## **PEER REVIEW SUMMARY REPORT**

### **Peer Review of the Industrial Waste Management Evaluation Model Version 3.0**

## **Peer Review of the Industrial Waste Evaluation Model (IWEM) Beta Version 3.0**

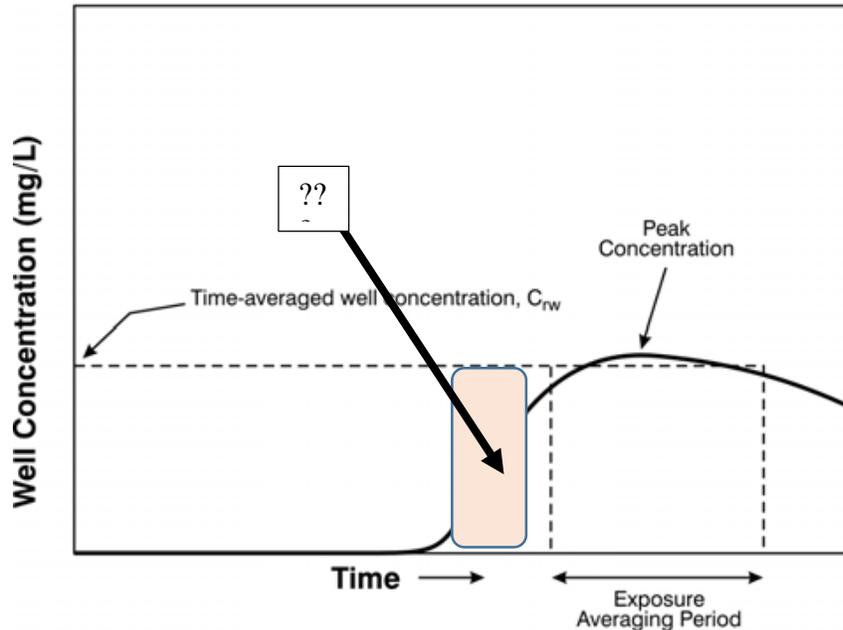
**Page 4-1, Figure 4.1:** What if the exposure averaging period belongs to another time range (see the pink domain below?) that only corresponds to (say) the raising part of the concentration breakthrough profile. Assume that the Trimester exposure period of a female is that period? Than what? Here the authors have described an ideal situation which is only one of the many possible cases. This is misleading and not correct.

Figure ES-1 Conceptual cross-section view of the subsurface system simulated by EPACMTP.

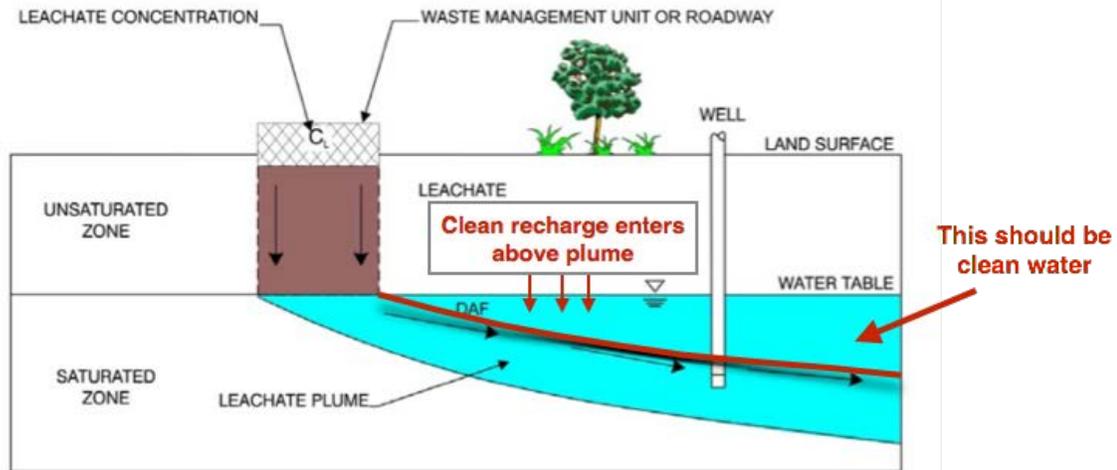
*i.* A set of figures (2-6 in Users Guide, ES-1, 2-3, 6-3 in the Technical Document) show a cross section through a plume emanating from a source. All of the figures show the contaminated water filling the area below the water table down to what appears to be a flow line emanating from the upstream edge of the source. Is this really what the simulated plumes look like? Does the model neglect clean recharge entering above the

plume and displacing the plume downward in the aquifer? This appears inconsistent with the description of recharge (section 6.3.3 in Technical Document). In the figure below, I show what the plume should look like. Contaminant plumes can pass beneath shallow well screens. The figures in the report appear to show that this can never happen.
